# Access Compliance Report

## Public Rights-of-Way

### (Curb Ramps)

Intersection ID: 12640	Main Street: W_MOREHEAD_ST	Cross Street: WILKINSON_BV	Location: NW
ADA ID: 4B4A834B790D	Ramp Type: Perp	Initial Pass/Fail: Fail	Overall Compliance: No
Severity Score: 10			
Codes/Mitigation Info/Possible Solution		Field Measurements/Component Compliance

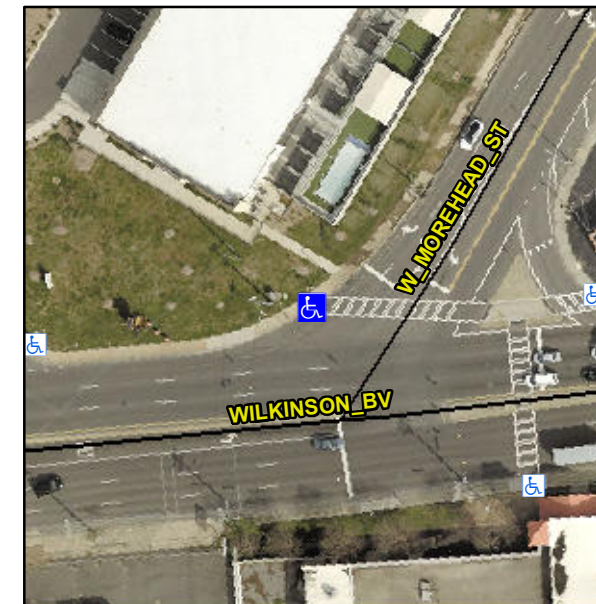
**Not Found, R304.5.1, R304.5.3**

Compliance	Description	Data	Compliance	Description	Data
N/A	Ramp Length (in)	70.0	Yes	Ramp Slope (%)	5.0
No	Ramp Width (in)	47.0	No	Ramp XSlope (%)	2.3
N/A	Flare Type LT	N/A	N/A	Flare Type RT	N/A
N/A	Flare Slope LT (%)	N/A	N/A	Flare Slope RT (%)	N/A
N/A	Flare Traversable LT?	N/A	N/A	Flare Traversable RT?	N/A
N/A	Landing Length (in)	N/A	N/A	DWS Provided?	N/A
N/A	Landing Width (in)	N/A	N/A	DWS Contrast?	N/A
N/A	Landing Slope (%)	N/A	N/A	DWS Length (in)	N/A
N/A	Landing X Slope (%)	N/A	N/A	DWS Full Width?	N/A
N/A	Landing Curb? (Y/N)	N/A	N/A	DWS Offset (in)	N/A
N/A	Shared Landing?	N/A			
N/A	Gutter Ponding?	N/A	N/A	Gutter Slope (%)	N/A
N/A	Gutter Lip Ht (in)	N/A	N/A	Gutter X Slope (%)	N/A
N/A	Painted X Walk1?	Yes	N/A	Painted X Walk2?	N/A
	X Walk 1 Direction	To E		X Walk 2 Direction	N/A
N/A	X Walk 1 Width (in)	96.0	N/A	X Walk 2 Width (in)	N/A
	X Walk 1 Slope (%)	0.7		X Walk 2 Slope (%)	N/A
	X Walk 1 X Slope (%)	1.8		X Walk 2 X Slope (%)	N/A

**Remove & Replace Entire Ramp.**
